ISSUE	DATE	AMENDMENT
01	25.06.10	For inclusion in Development Application
02	27.07.10	New elevations for inclusion in Development Application
03	15.10.10	Council request for additional information
04	28.01.11	Council request for additional information

DEVELOPMENT APPLICATION
New Independent Living Units
Lourdes Village
95 Stanhope Road, Killara
For Aevum Limited

DWG NO
DA.00

TITLE	Stanhope - Ground Plan
ISSUE	C
SCALE	1:100 @ A1
DATE	09.06.10
DRAWN	JK/KC
CHECKED	PT
0 1 5 10 metres

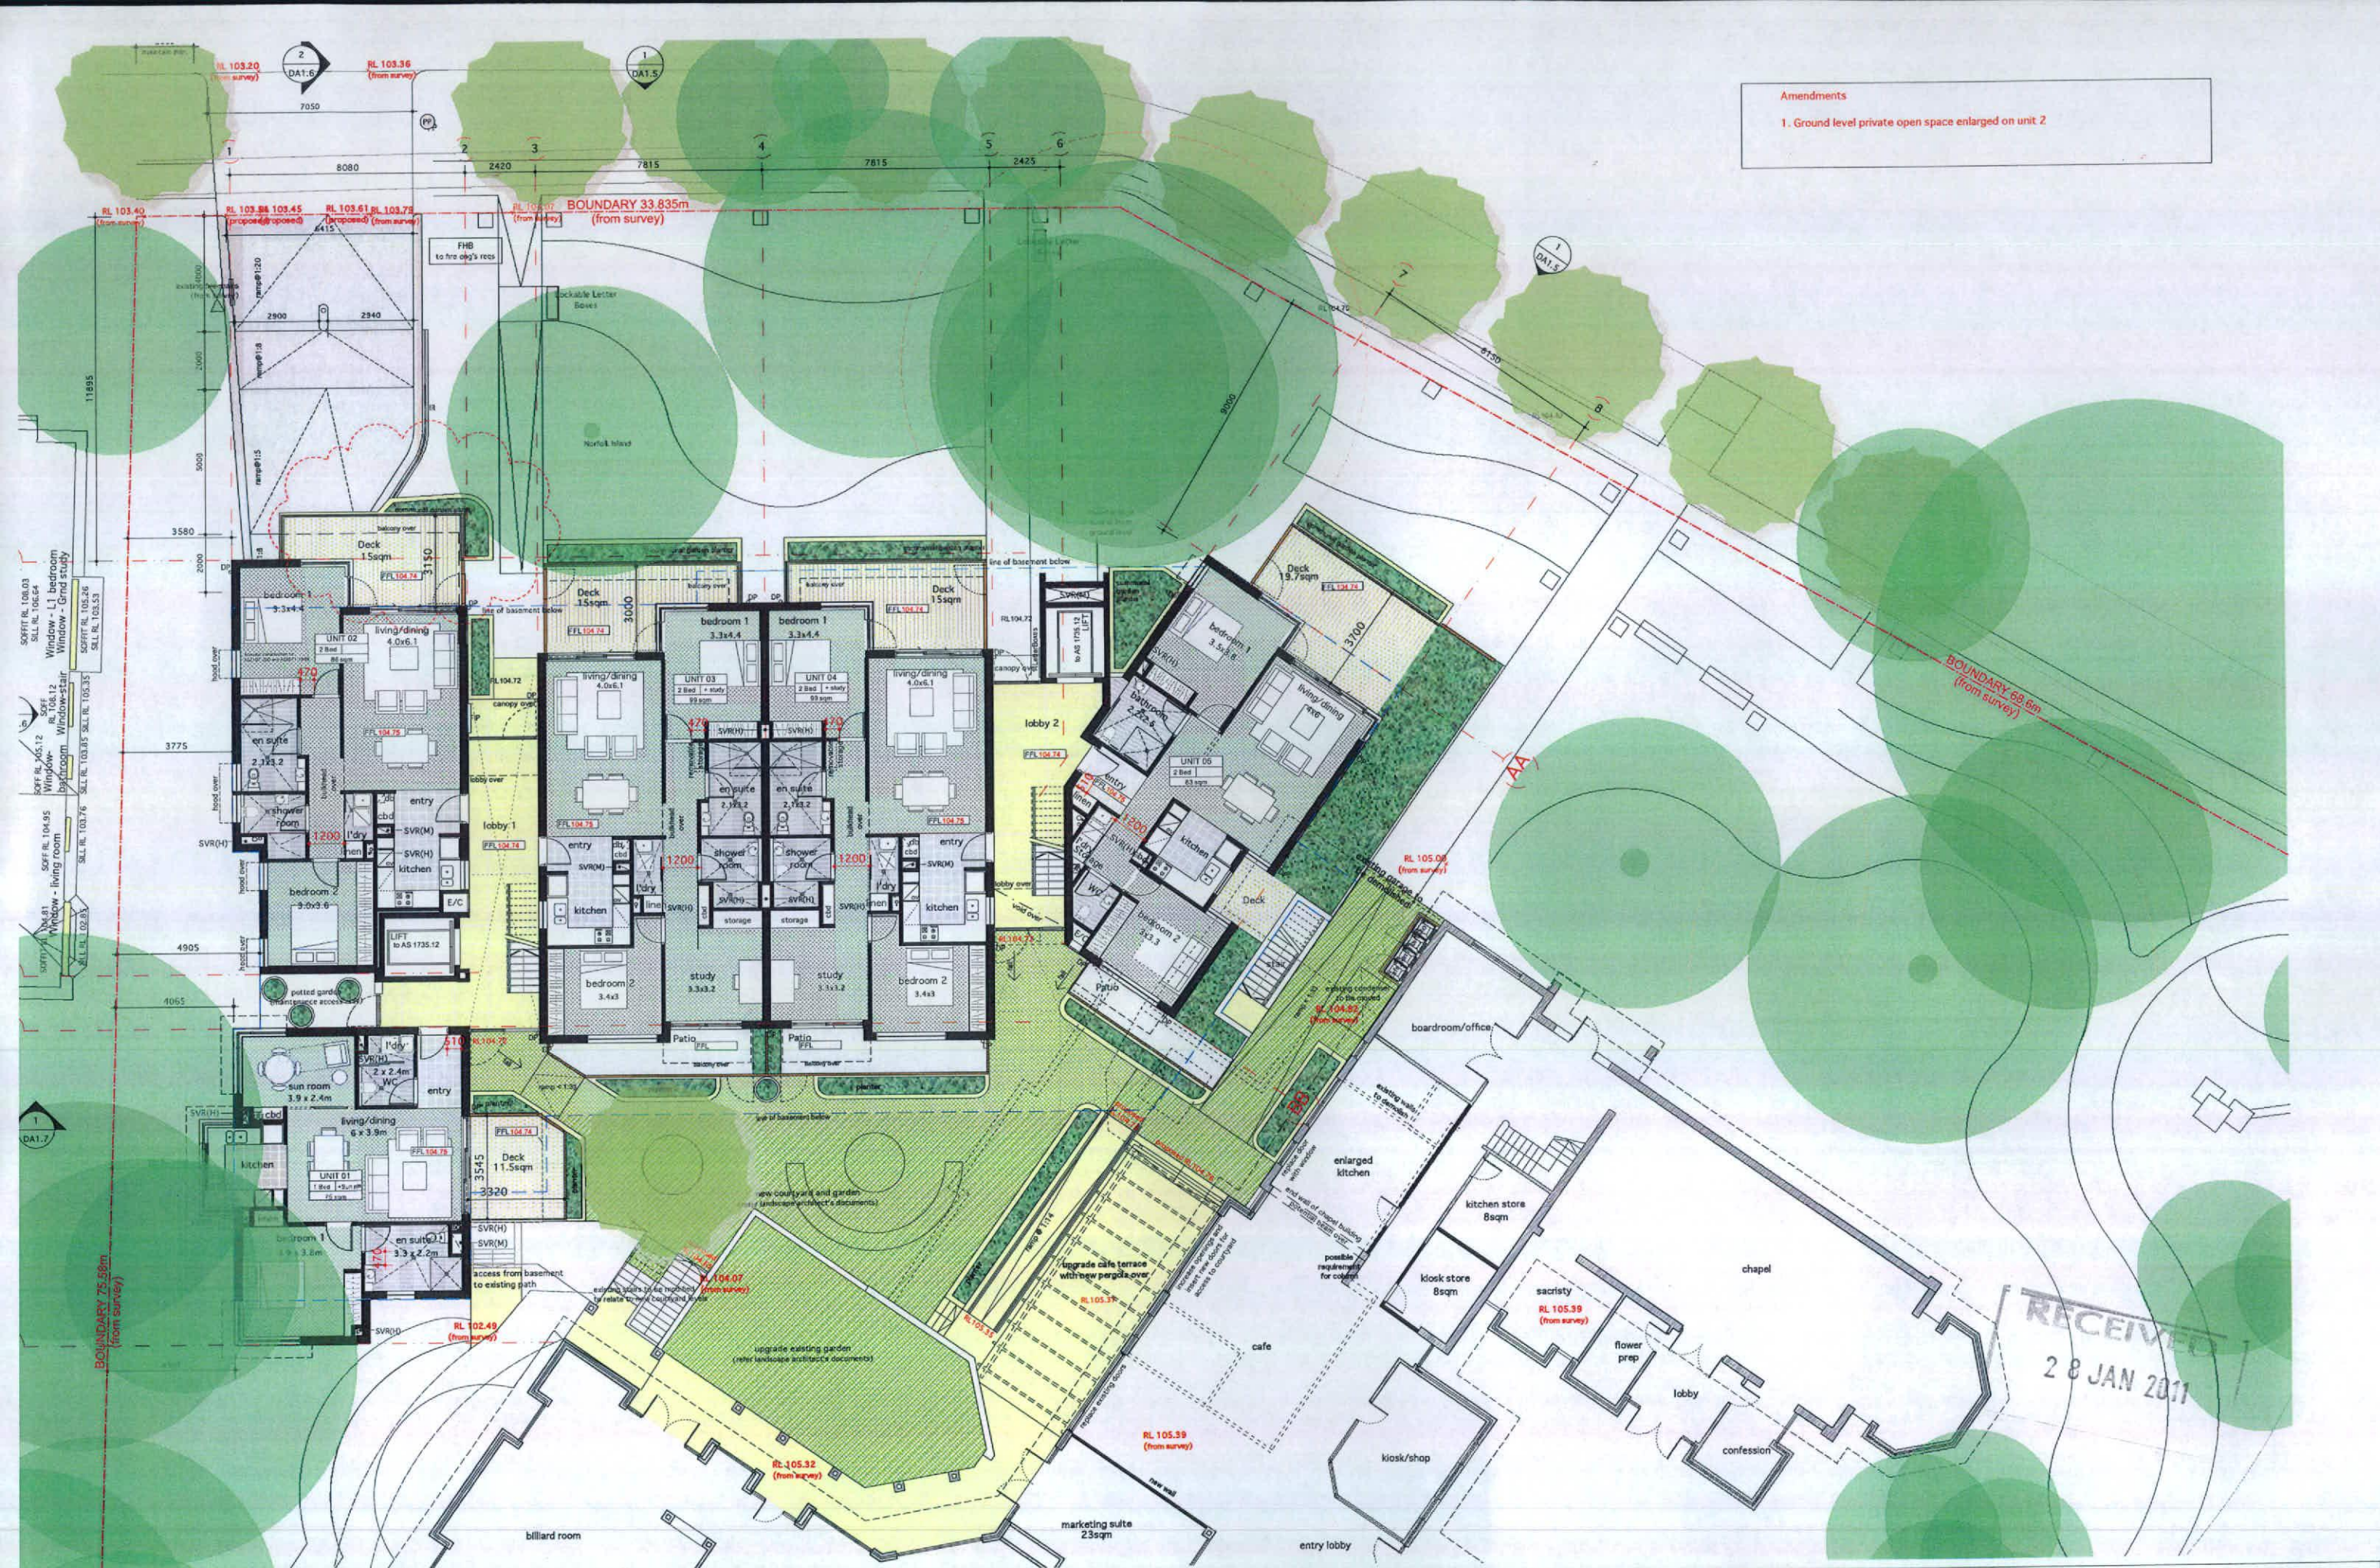
1. Ground level private open space enlarged on unit 2

TITLE	SCALE	DATE	DRAWN	CHECKED
Stanhope - Level 1 Plan	1:100 @ A1	MAR '10	JKICK	PT
0 1 5 10 meters

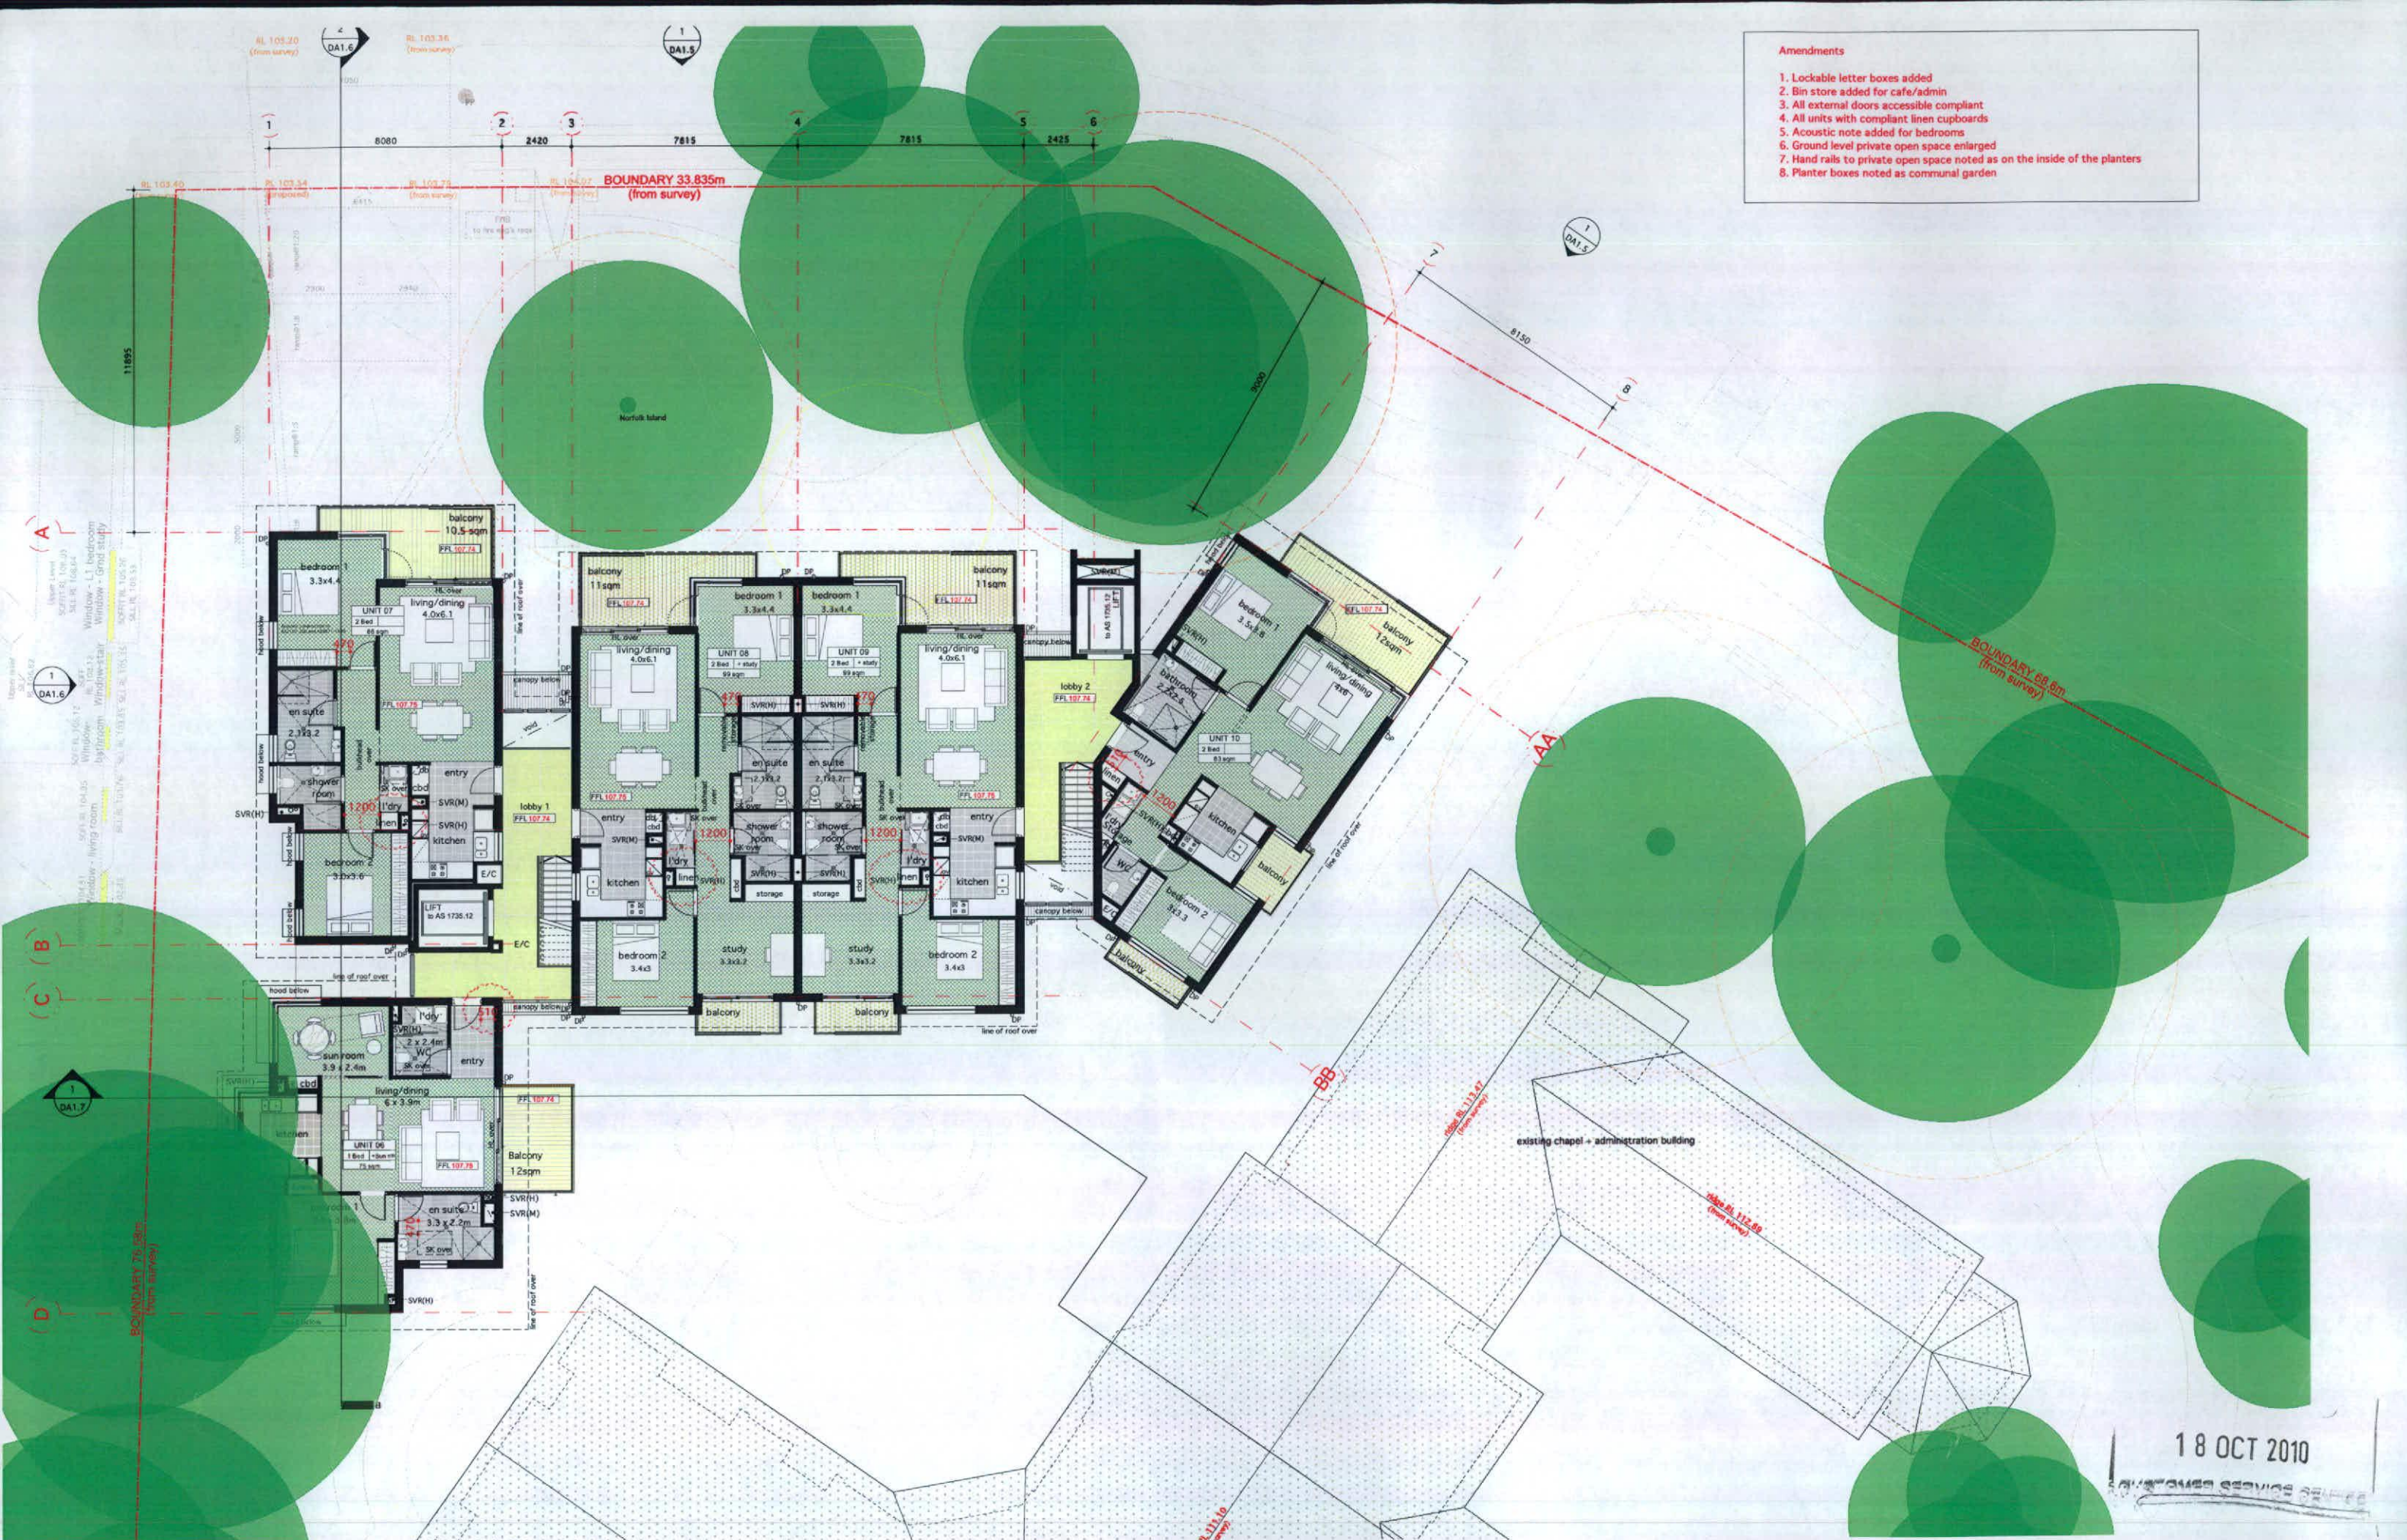
1. Lockable letter boxes added
2. Bin store added for cafe/admin
3. All external doors accessible compliant
4. All units with compliant linen cupboards
5. Acoustic note added for bedrooms
6. Ground level private open space enlarged
7. Hand rails to private open space noted as on the inside of the planters
8. Planter boxes noted as communal garden

TITLE		Stanhope - Elevation NW	
ISSUE	SCALE	DATE	DRAWN: CHECKED:
C	as shown	09.06.10	JKCK PT
0	1	5	10
1:100 @ A1		metres

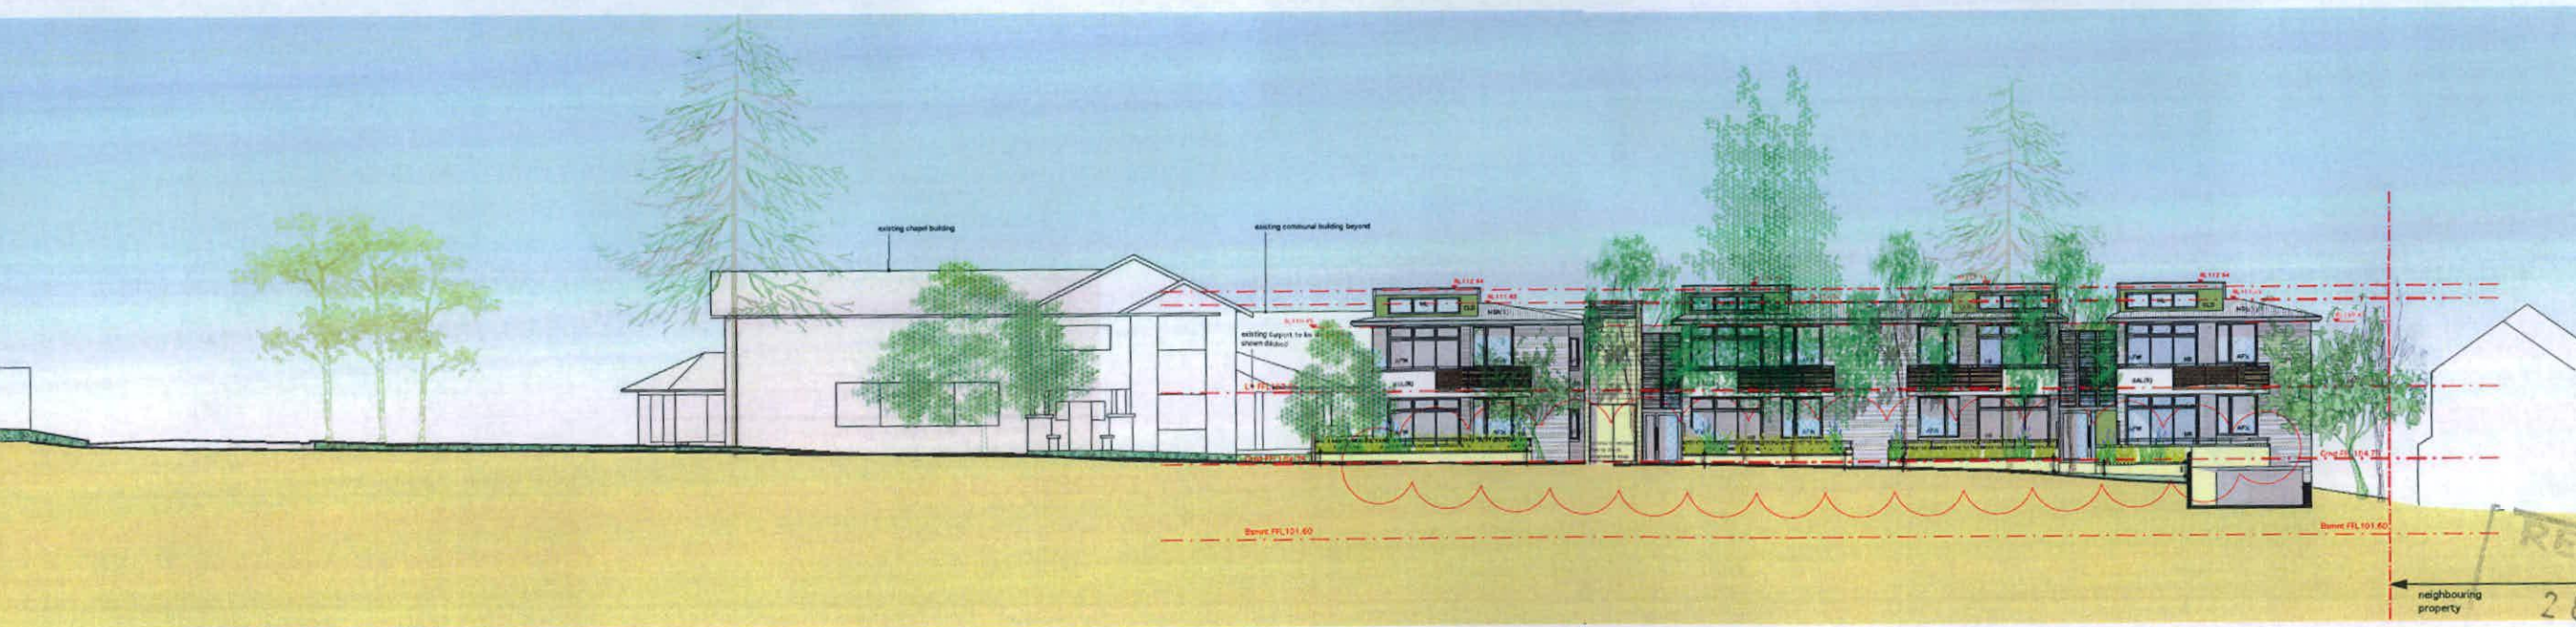
Amendments
1. Planter wall lowered
